Request to adopt the updated Land Use Policy Application document

REQUEST

Adopt the updated Land Use Policy Application document

Planned Unit Development 65-82-U-10 Maryland Farms Commercial PUD

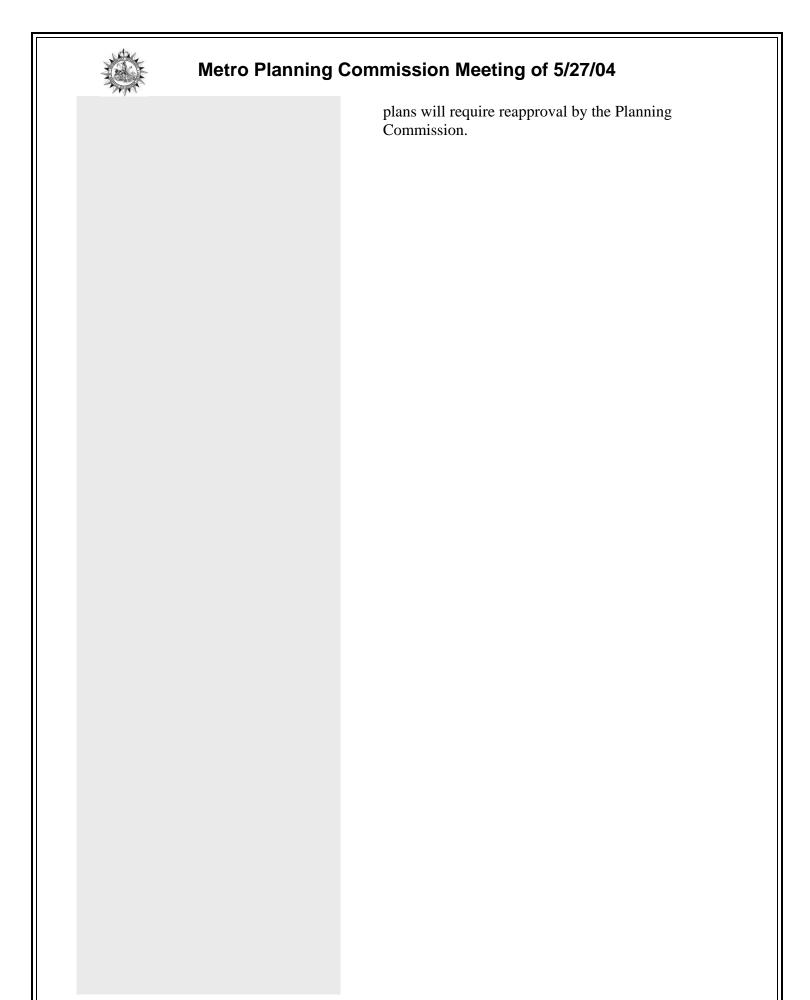
This revision proposes a setback of 17 feet, an encroachment into the platted side yard setback of 30 feet by 13 feet. In addition to recommending that a revised plat be recorded to amend the platted setback,

_
	staff is also recommending that additional landscaping above the minimum buffer requirement, be provided along the side of the building facing Brentwood Boulevard.
METRO PUBLIC WORKS' RECOMMENDATION	All comments provided as part of the plan review process were successfully addressed.
CONDITIONS	1. Prior to the issuance of any building permits, the associated subdivision plat, entitled Maryland Farms East Park, Resubdivision of Tract One (Boo 6250, Page 1), shall be amended to reflect the new western side setback line of 17 feet.

Project access #4

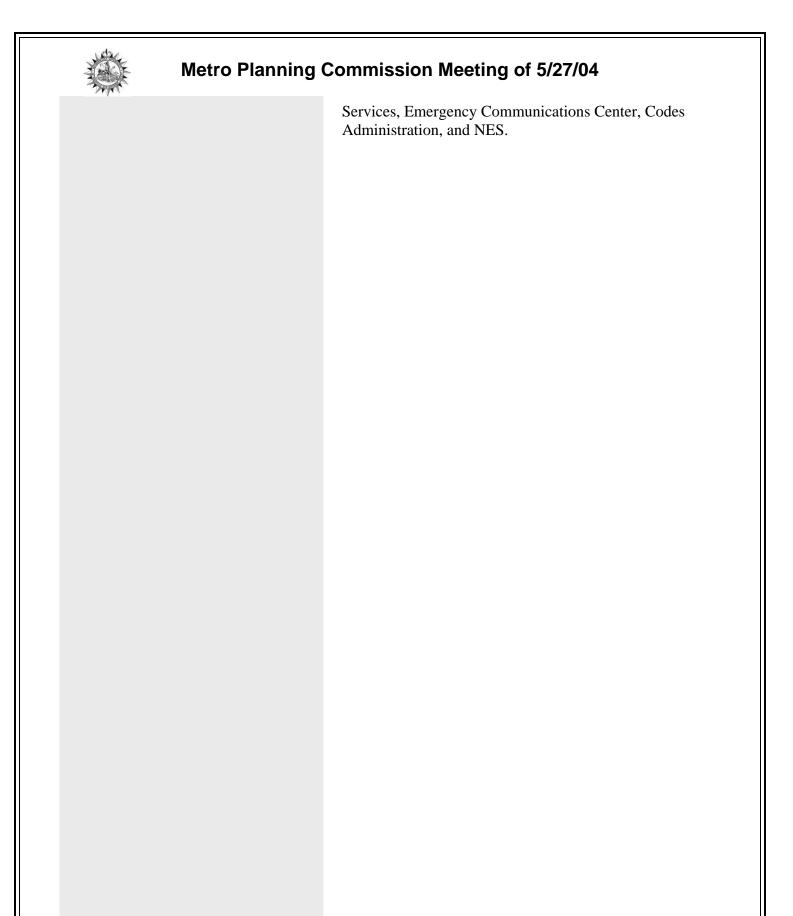
- 1. Install separate 11 ft wide WB left turn and right turn lanes and 11 ft wide entering lane for access #4 road
- 2. Install 12 ft wide SB left turn on Nolensville RD with 75 ft of storage length in
- 2-way left turn lane
- 3. Install NB right turn lane
- 4. No on street parking shall be provided for 75 ft from intersection
- 5. Provide adequate sight distance
